Access Compliance Report

Public Rights-of-Way

Intersection ID: 26345	Main Street: BEAUCATCHER_LN	Cross Street: RHETT_BUTLER_PL	Location: NW
ADA ID: 86B03C9F0EC0	Ramp Type: BlendTrans2	Initial Pass/Fail: Fail	Overall Compliance: No
		Severity Score: 1.25

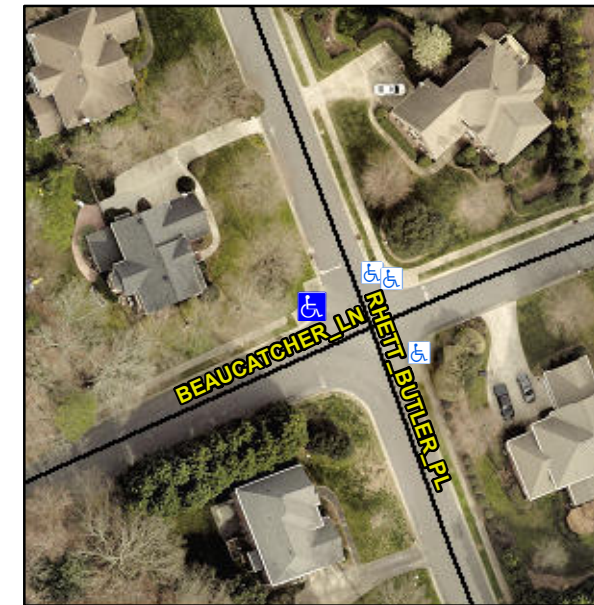
Not Found, R304.5.3

Compliance	Description	Data	Compliance	Description	Data
N/A	Ramp Length (in)	95.0	Yes	BlendTrans Slope (%)	2.5
Yes	Ramp Width (in)	62.0	No	BlendTrans XSlope (%)	2.1
N/A	Flare Type LT	N/A	N/A	Flare Type RT	N/A
N/A	Flare Slope LT (%)	N/A	N/A	Flare Slope RT (%)	N/A
N/A	Flare Traversable LT?	N/A	N/A	Flare Traversable RT?	N/A
N/A	Landing Length (in)	N/A	N/A	DWS Provided?	N/A
N/A	Landing Width (in)	N/A	N/A	DWS Contrast?	N/A
N/A	Landing Slope (%)	N/A	N/A	DWS Length (in)	N/A
N/A	Landing X Slope (%)	N/A	N/A	DWS Full Width?	N/A
N/A	Landing Curb? (Y/N)	N/A	N/A	DWS Offset (in)	N/A
N/A	Shared Landing?	N/A			
N/A	Gutter Ponding?	N/A	N/A	Gutter Slope (%)	N/A
N/A	Gutter Lip Ht (in)	N/A	N/A	Gutter X Slope (%)	N/A
N/A	Painted X Walk1?	No	N/A	Painted X Walk2?	No
	X Walk 1 Direction	To SE		X Walk 2 Direction	To NE
	X Walk 1 Width (in)	N/A		X Walk 2 Width (in)	N/A
	X Walk 1 Slope (%)	4.1		X Walk 2 Slope (%)	3.1
	X Walk 1 X Slope (%)	4.9		X Walk 2 X Slope (%)	1.0

Remove & Replace Curb Ramp With Two New Directional Ramps or Equivalent.
